ABS Rear Valve Harness **Recall Work Instructions**

Recall # 09V-127

Models Affected: All Allegro Buses built on a PowerGlide chassis from May 1, 2007 through April 14, 2009.

ABS REAR VALVE HARNESS REWORK INSTRUCTIONS

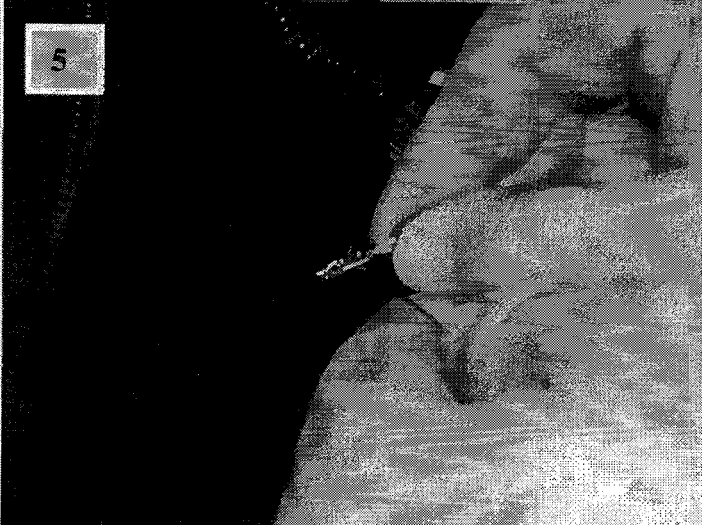
Figure 2. Shows plug removed and location of loads 2(Brn) and 5(Blue). Also, loads 8(Brn) and 9(Blue) will need to be located as well. These are the four circuits that will need to be serviced. At this point label each circuit according to its current load. This will help to insure proper reloading of circuits later.

BELOW IS SPREADSHEET SHOWING THE DESIRED PIN OUT REVISION

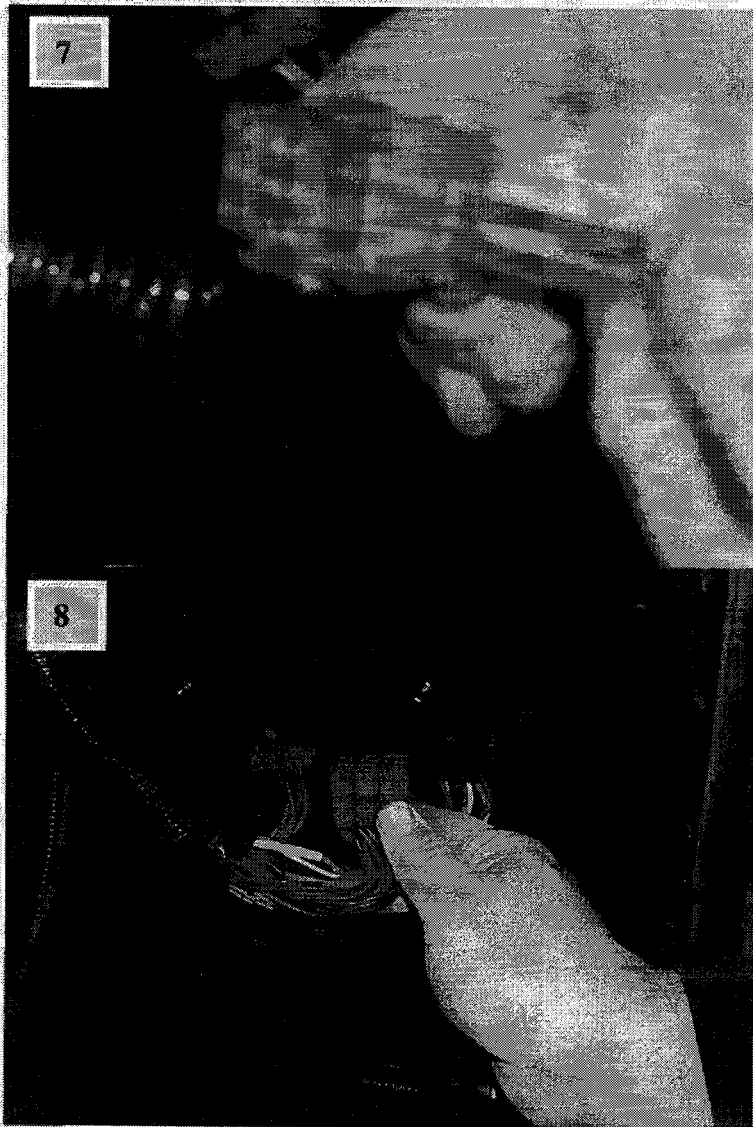
The net result needed will be for the circuits loaded into 2 and 5 to be removed and reinserted into loads 8 and 9. At the same time, the circuits loaded in 8 and 9 will be removed and reloaded into plug loads 2 and 5. Net result is to swap the loads for the two pairs of circuits.

CABLE	CIRCUIT	COLOR	CKT DESCRIPTION	PLUG	REV'D LOAD	COMMENT
CA21-TT	276	BRN	CA-449.533-RR3	P126	8	was P126/2
CA21-TT	278	BLUE	CA-449.533-RR1	P126	9	was P126/5
CA22-TT	279	BRN	CA-449.533-RL3	P126	2	was P126/8
CA22-TT	281	BLUE	CA-449.533-RL1	P126	5	was P126/9
